Addendum #1 - Bid Package #6929-07

Project Name: Lincoln Public Schools District Office
5901 'O' Street
Lincoln, NE
Project No.: 11065
Issued: August 3, 2012

Sketch A1
 Bid Package 6929-07
 Addendum 01

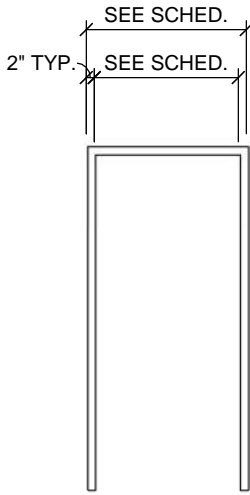
ADD 1-13. Refer to Sheet A400, Detail D13; Modifications have been made to the requirements of the bent plates that support the glazing on the exterior canopies. The width of the horizontal is 4” at the gutter and 2” at all other locations. Refer to attachment **Sketch A1.**

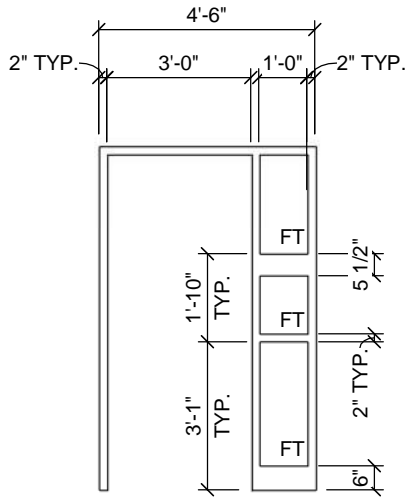
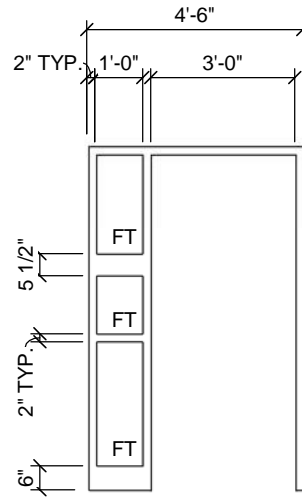
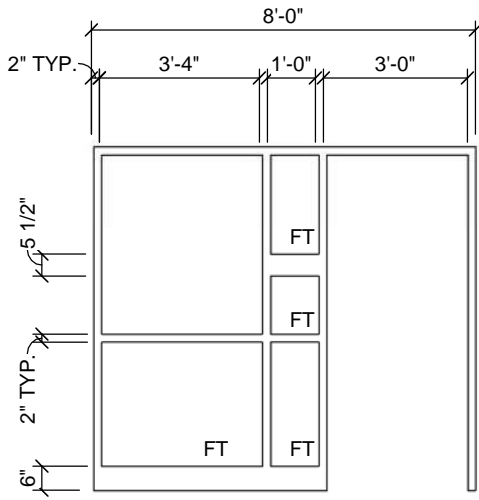
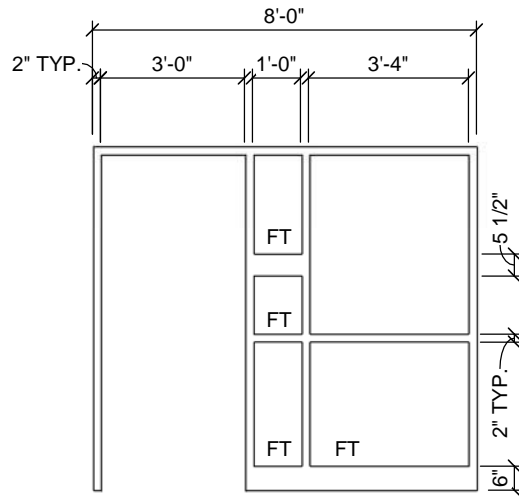
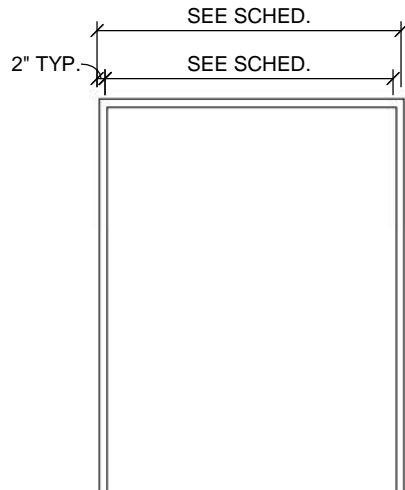
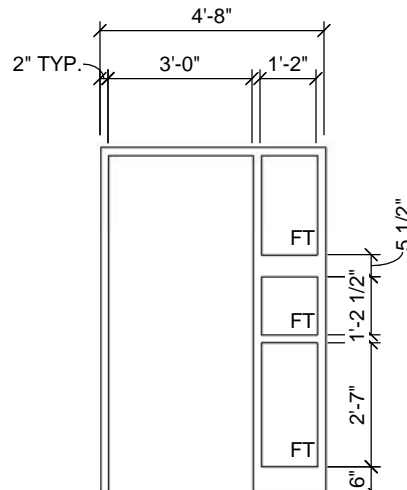
ADD 1-14. Refer to Sheet A502; HM FRAME TYPES were inadvertently left out of the drawings. Refer to Attachment **Sketch A2** for the HM Frame Types.

08.03.2012
 SHEET
M100
 ATTACHMENT NO.
M1
 TSM

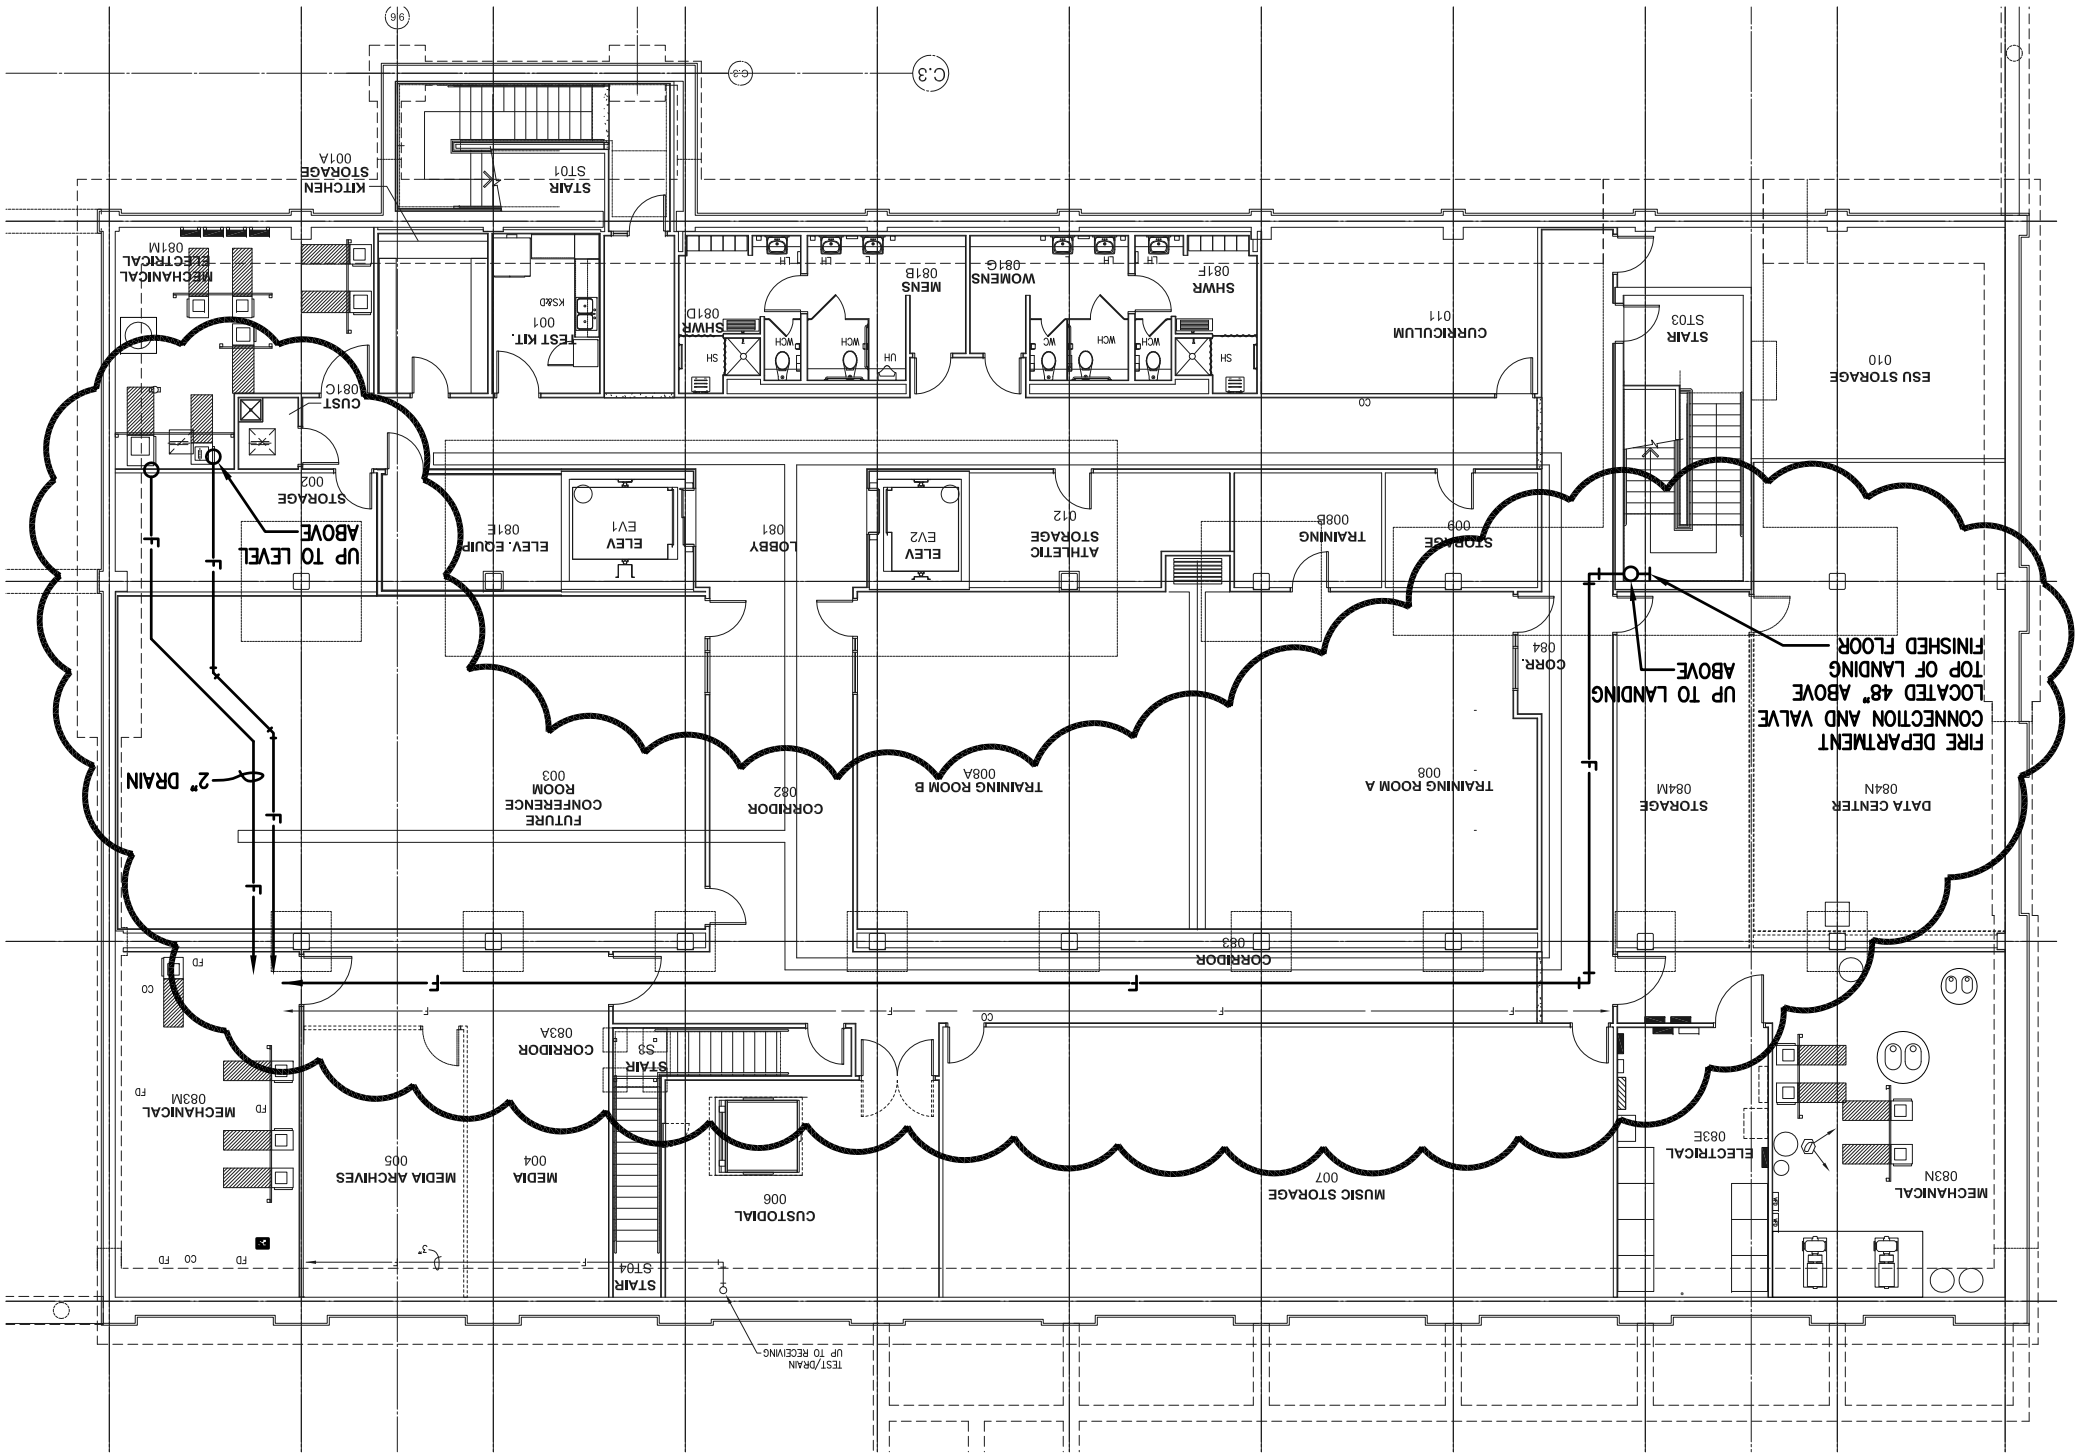
ADD 1-15. Refer to Sheet M100 – Basement Plan – Mechanical

- A. Refer to **attachment M1** for revised fire sprinkler piping.
 - i. Relocate flow switches for 1st, 2nd and 3rd floor as shown in **attachments M3, M4 and M5.**
